Access Compliance Report

Public Rights-of-Way

Intersection ID: 49148	Main Street: VERNEY_LN	Cross Street: OLD_PROVIDENCE_LN	Location: SW
ADA ID: 51806B5FF17B	Ramp Type: PerpDiag	Initial Pass/Fail: Fail	Overall Compliance: No
		Severity Score: 50

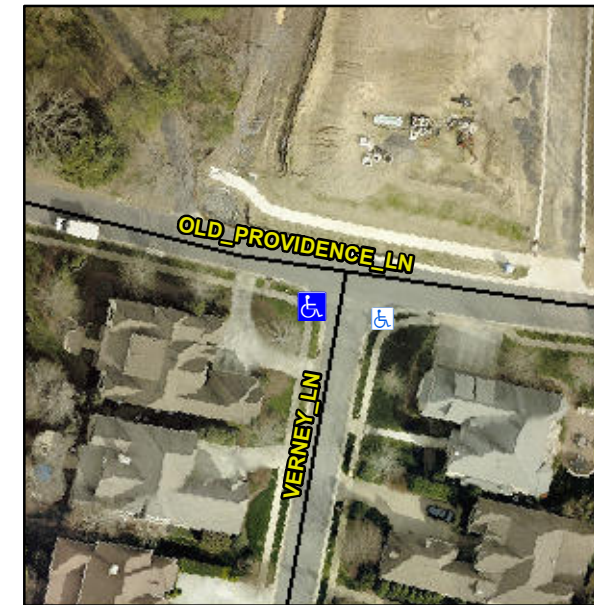
Not Found, R304.2.2, R304.5.3

Compliance	Description	Data	Compliance	Description	Data
N/A	Ramp Length (in)	50.0	No	Ramp Slope (%)	12.7
Yes	Ramp Width (in)	48.0	No	Ramp XSlope (%)	9.7
N/A	Flare Type LT	N/A	N/A	Flare Type RT	N/A
N/A	Flare Slope LT (%)	N/A	N/A	Flare Slope RT (%)	N/A
N/A	Flare Traversable LT?	N/A	N/A	Flare Traversable RT?	N/A
N/A	Landing Length (in)	N/A	N/A	DWS Provided?	N/A
N/A	Landing Width (in)	N/A	N/A	DWS Contrast?	N/A
N/A	Landing Slope (%)	N/A	N/A	DWS Length (in)	N/A
N/A	Landing X Slope (%)	N/A	N/A	DWS Full Width?	N/A
N/A	Landing Curb? (Y/N)	N/A	N/A	DWS Offset (in)	N/A
N/A	Shared Landing?	N/A			
N/A	Gutter Ponding?	N/A	N/A	Gutter Slope (%)	N/A
N/A	Gutter Lip Ht (in)	N/A	N/A	Gutter X Slope (%)	N/A
N/A	Painted X Walk1?	No	N/A	Painted X Walk2?	No
	X Walk 1 Direction	To SE		X Walk 2 Direction	To N
N/A	X Walk 1 Width (in)	N/A	N/A	X Walk 2 Width (in)	N/A
	X Walk 1 Slope (%)	3.0		X Walk 2 Slope (%)	5.4
	X Walk 1 X Slope (%)	5.4		X Walk 2 X Slope (%)	7.3

Remove & Replace Curb Ramp With Two New Directional Ramps or Equivalent.
